UNITED STATES PATENT AND TRADEMARK OFFICE

APPLICATION NO.	FILING DATE	FIRST NAMED INVENTOR	ATTORNEY DOCKET NO.	CONFIRMATION NO.
10/667,115	09/19/2003	Russell Norman Mirov	SUN03-0112	8531

Office Action Summary

DETAILED ACTION

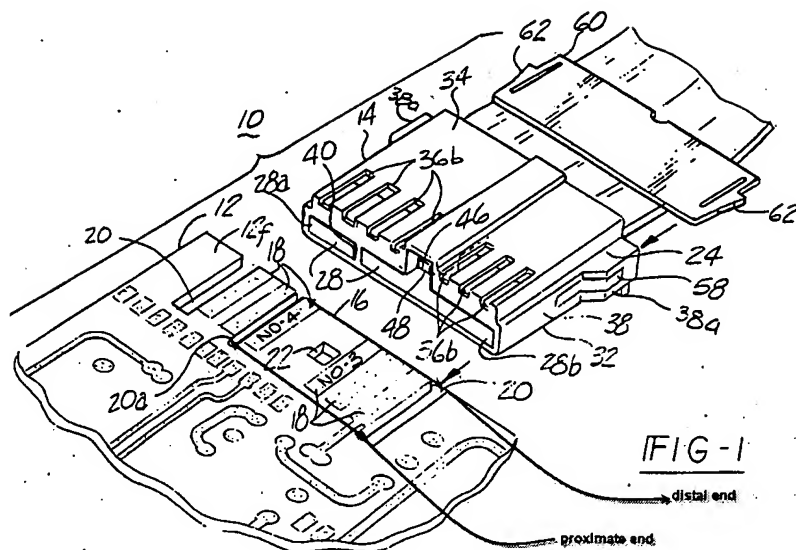
As to claims 1-3, Matson discloses a circuit board (12, column 2, line 7) as shown in figures 1-2 comprising: a mechanism (16, column 2, line 9) comprising:

signal means for (wire traces 18, and circuitries formed in/on the circuit board 12) conducting a signal between the mechanism (16) and the circuit board (12); and

separation means (gaps 20, column 2, line 15) for facilitating detachment of the mechanism (16) from the circuit board (12);

identification means for (labels No.1-No.6, figure 1 shows the label No.3 and No.4) identifying the mechanism (16);

wherein the circuit board becomes at least partly non-functional if the mechanism is detached from the circuit board.

As best understood to claims 34, 40-41, Matson discloses a circuit board assembly, shown in figure 1 comprising: a circuit board (12) comprising a tab (key tab-16) having: proximate and distal ends (see figure above); and two opposing sides separated from the assembly by gaps (slots 20); an identification (labels N0.1-No.6 formed on conductor runs 18 to identify the function of leads/pins of the conductor runs) situated on the tab (16); and a signal conductor (traces or wirings on the board) extending from the circuit board to the tab and configured to convey a signal when the assembly is powered, and wherein removal of the key from the circuit board assembly causes said portion of the signal conductor to be not electrical contact to the assembly.
